PROJECT TITLE
Royal Northern College of Music

DRAWING TITLE
East & West Elevations
Existing & Proposed

DRAWING NO.
PR1-IPA- Z1-18_4-GA-A-200505

1 East Elevation_Existing
1 : 100

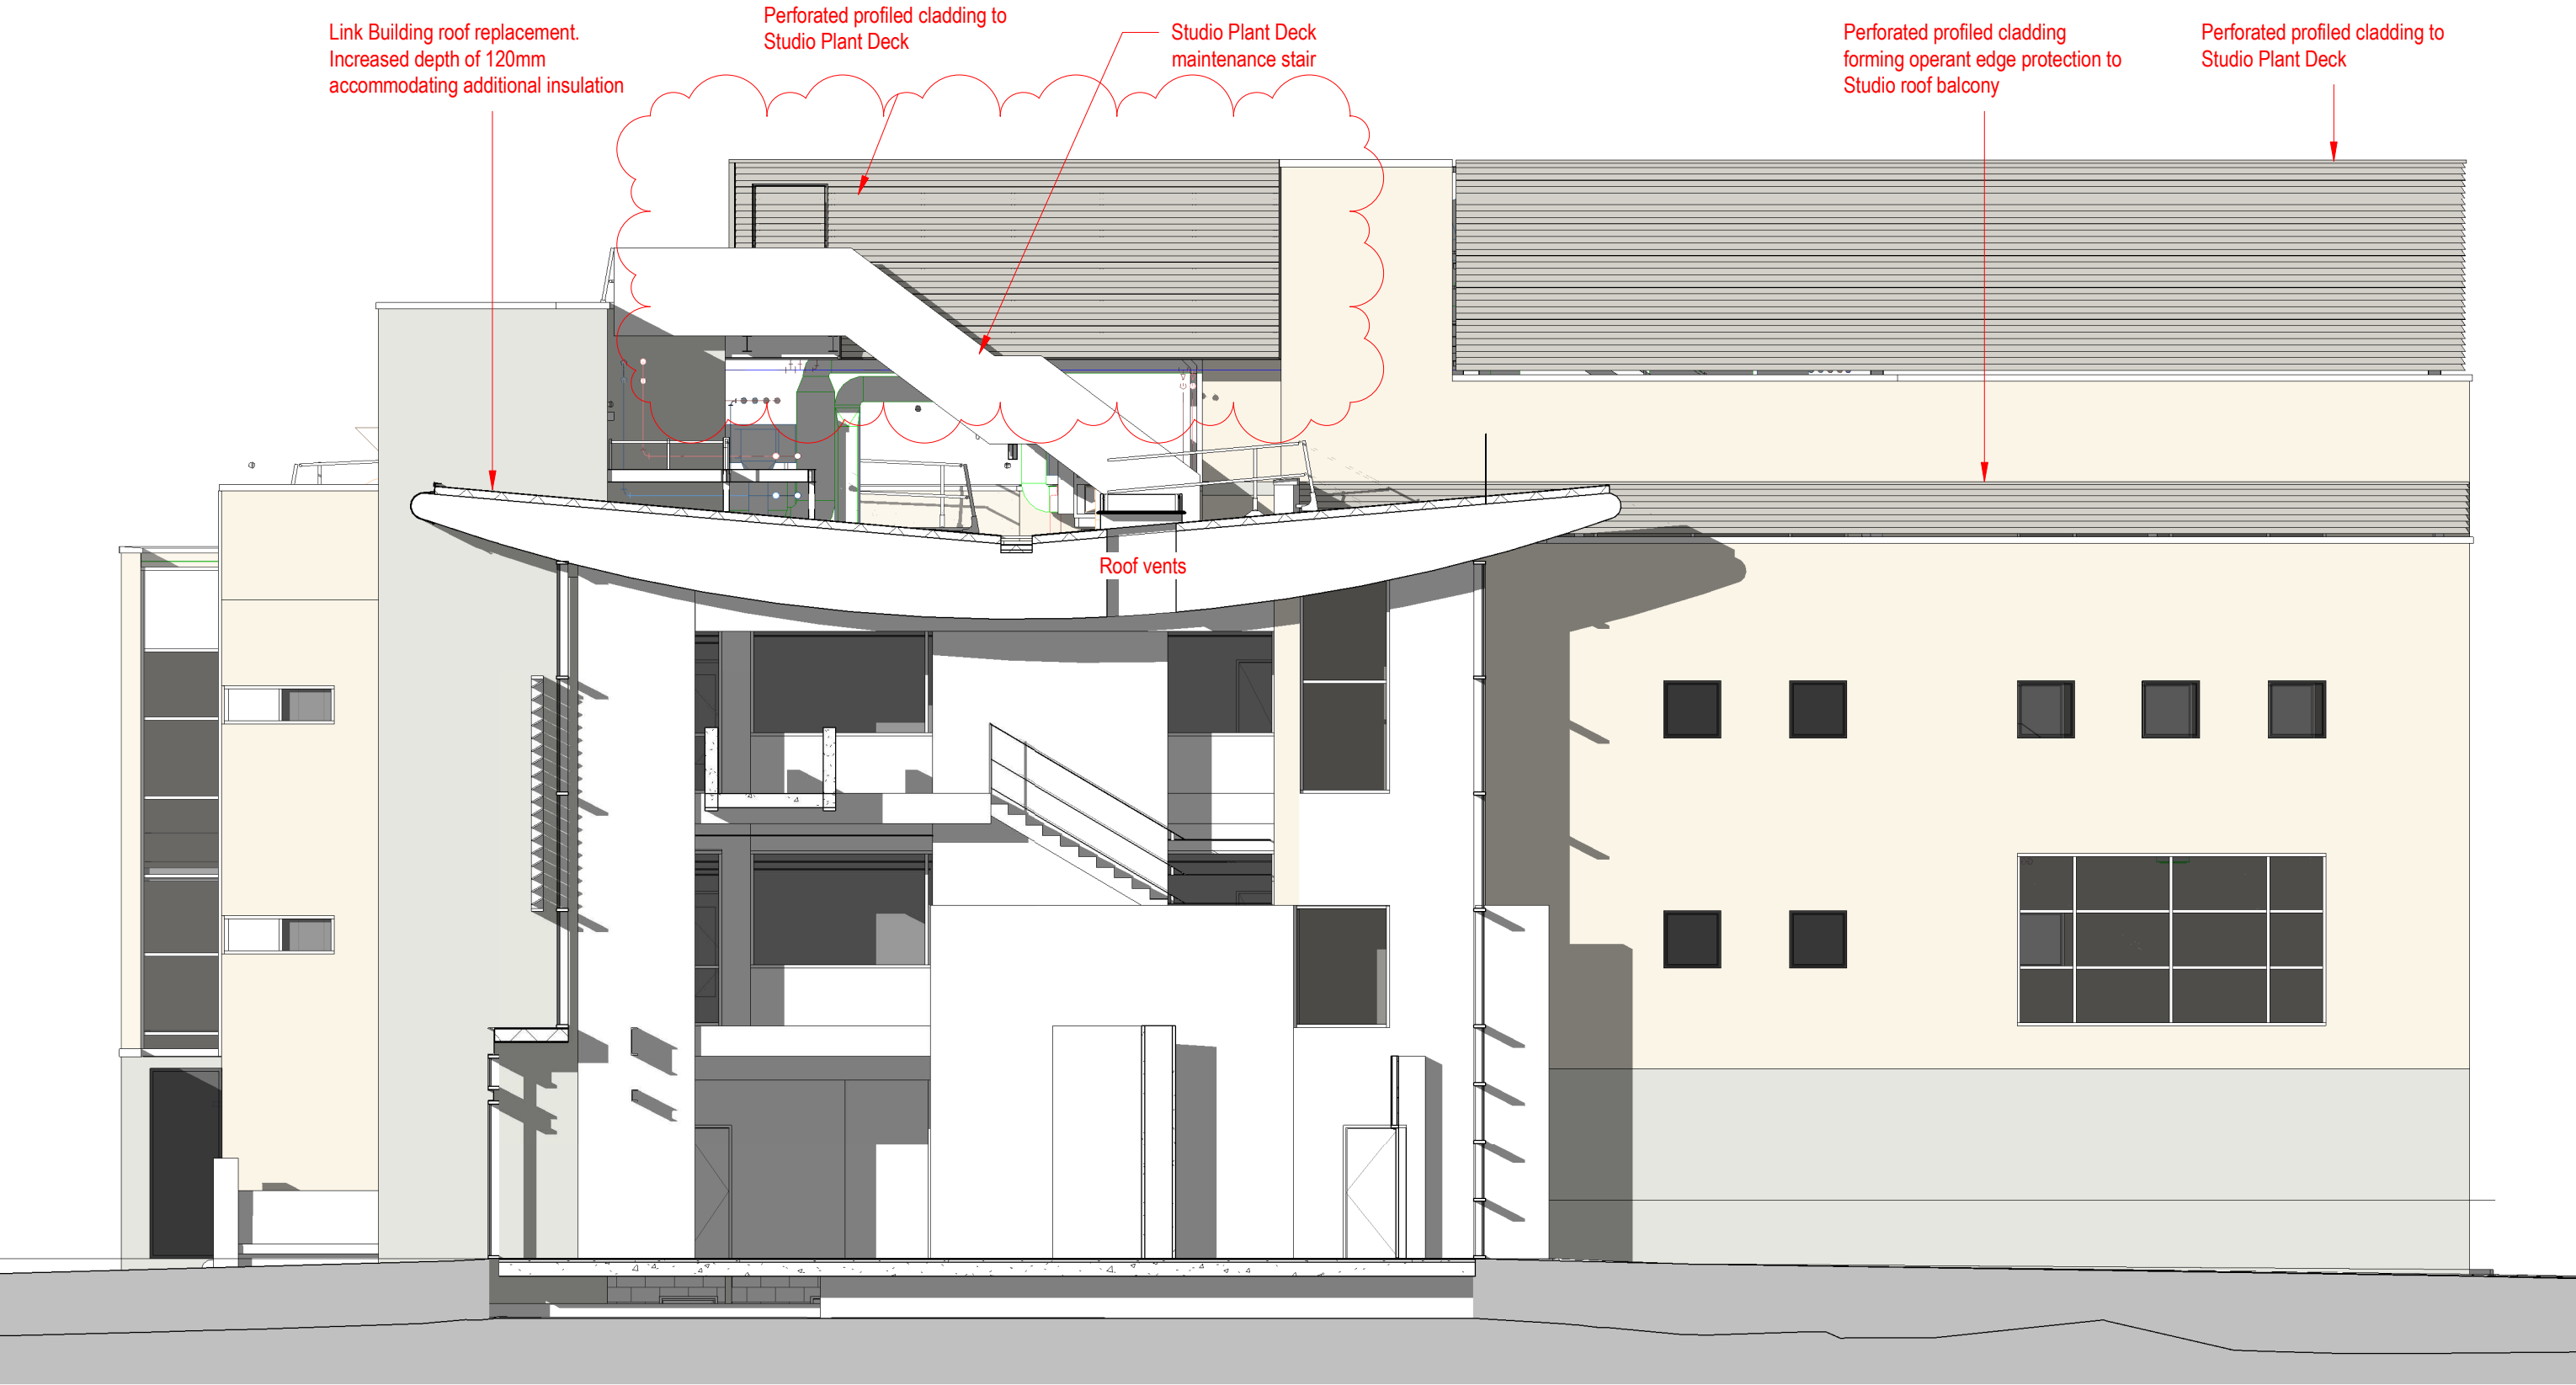
Roof light replaced - lower pitch required to accommodate roof overlay thickness.
Ref to Z1-00-SK-A-001 & 002
